CITY OF OAKLAND
AGENDA REPORT

RE: Supplemental Report, Public Hearing and Upon Conclusion Adopt A Resolution Approving the MacArthur Transit Village (a) Stage One (1) Final Development Plan Permit, Which Would Allow for Development of a New BART Parking Garage and Site Infrastructure, as Part of the MacArthur Transit Village Planned Unit Development (PUD060058), Pursuant to City Council Resolution No. 81422 C.M.S. Condition of Approval #27, and (b) Vesting Tentative Tract Map 8047, as recommended by the Planning Commission

This supplemental reports includes revisions to the VTTM (see *Attachment B: Revised TTM8047*) and a response to questions raised by a neighboring property owner regarding the ability to rely on the previously certified 2008 Environmental Impact Report (EIR) prepared in compliance with the California Environmental Quality Act (CEQA) (see *Attachment C: CEQA Memo*) and the street vacation process.

OAKLAND
 VESTING TENTATIVE TRACT MAP NO. 8047
 TENTATIVE MAP
 SANDIS

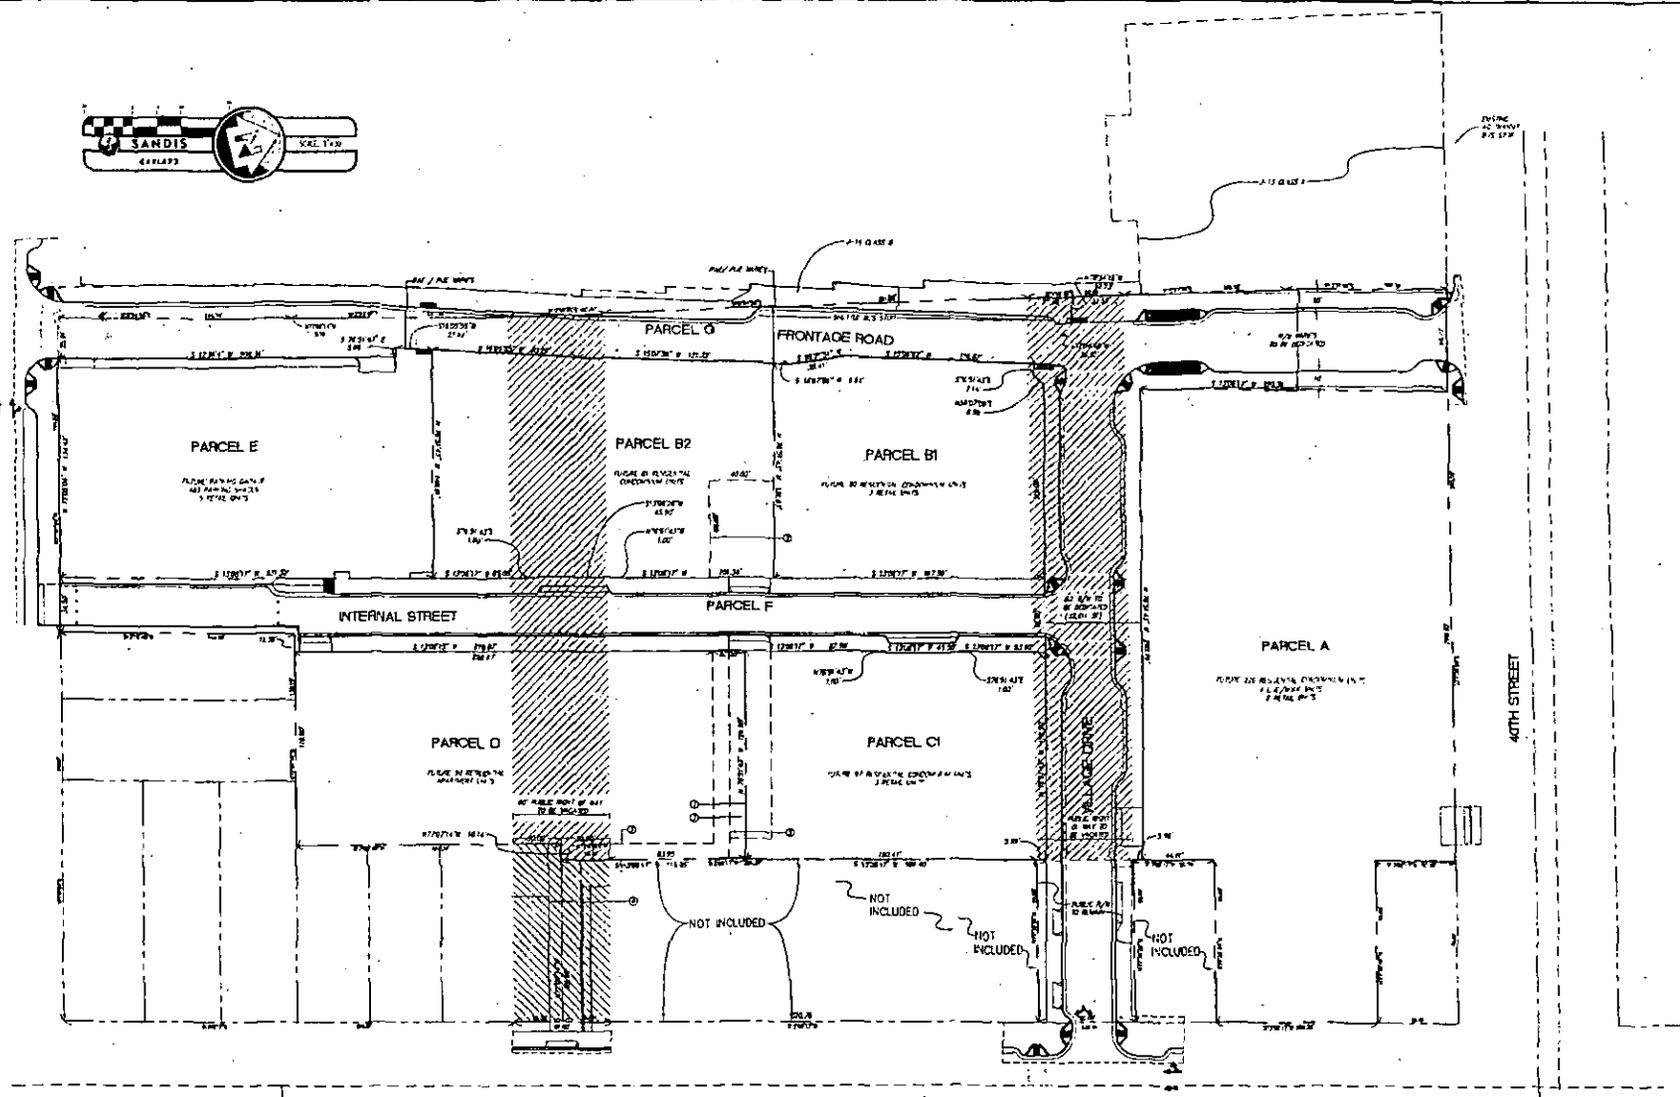
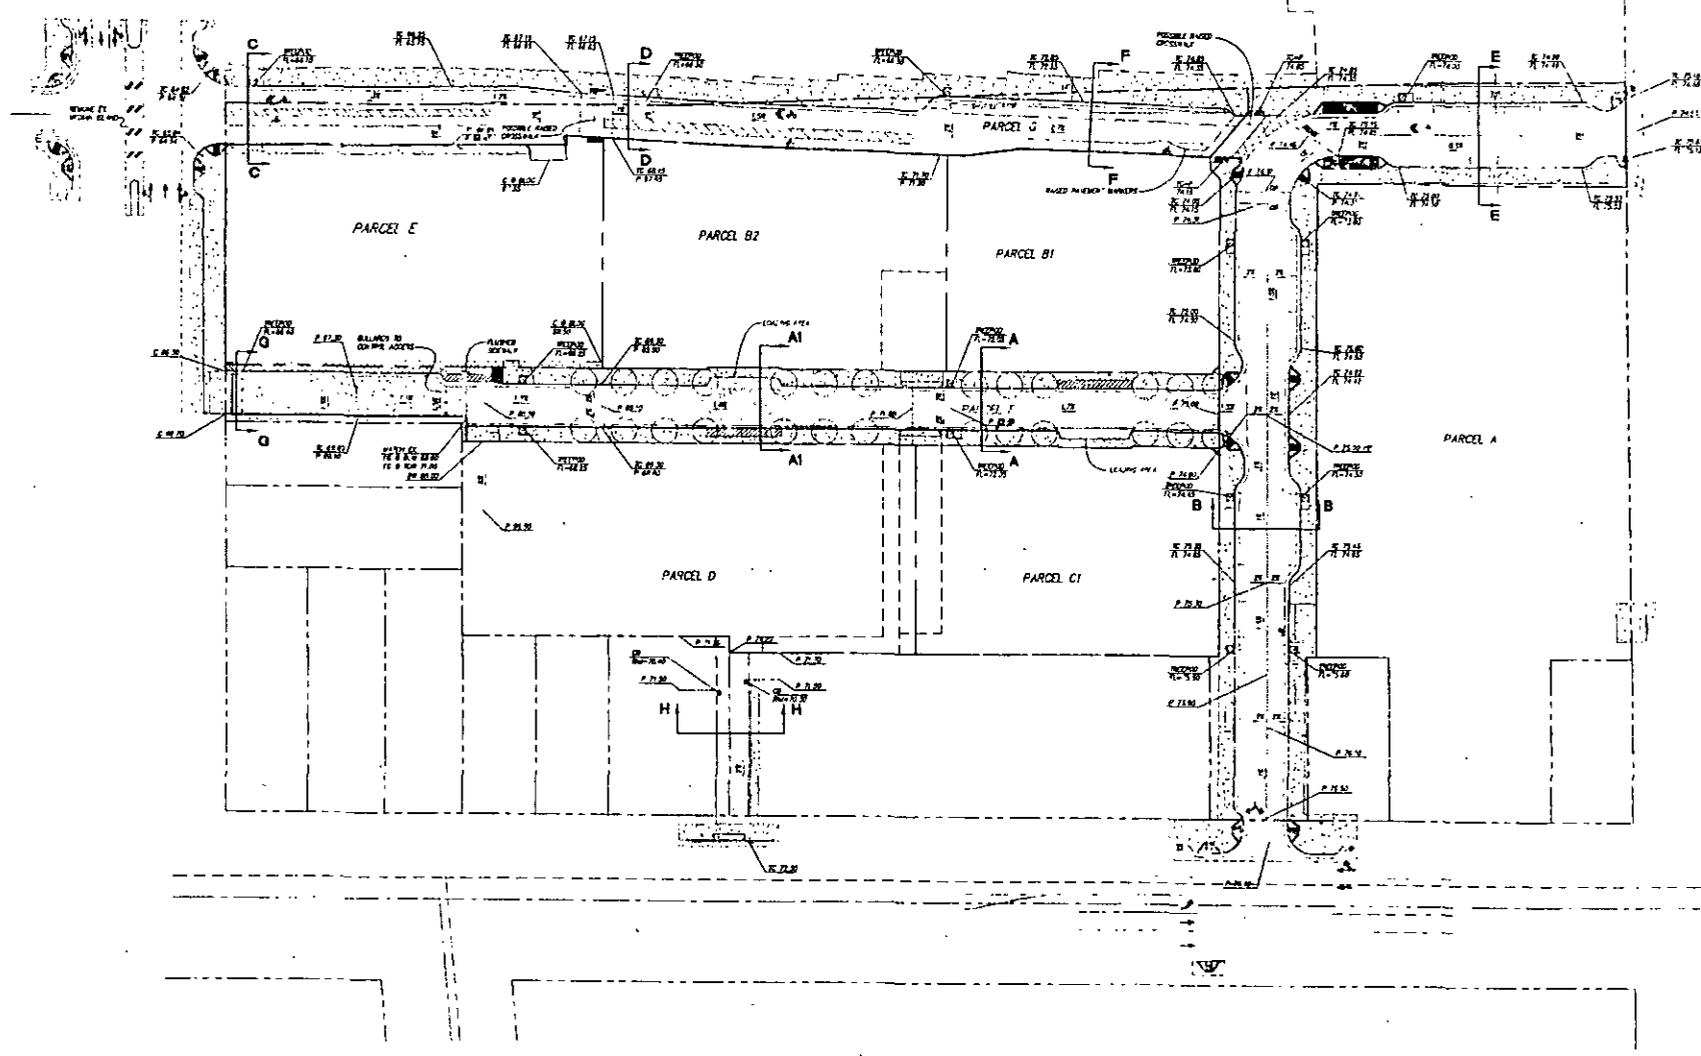
Since the Planning Commission reviewed the VTTM (TTM8047), City staff has determined that the portion of the Apgar right-of-way to be vacated should extend to Telegraph Avenue. The revised VTTM (dated February 28, 2011), see Attachment A, now indicates that the portion of the Apgar Street right-of way between the BART parking lot and Telegraph Avenue will be vacated. This section of the vacated Apgar right-of way will be encumbered with a 60-foot wide Public Service Easement which will allow fire access, pedestrian access and public utilities within the property (see Attachment B). The property will also have an access easement granting access to the properties fronting both sides of the present Apgar Street right-of way.

In addition to the proposed minor change to Apgar Street, the proposed VTTM includes additional information about existing Caltrans and BART ownership for the purpose of map clarification. These revisions result only in information clarification, apply only to cross-sections, and are non-substantive.
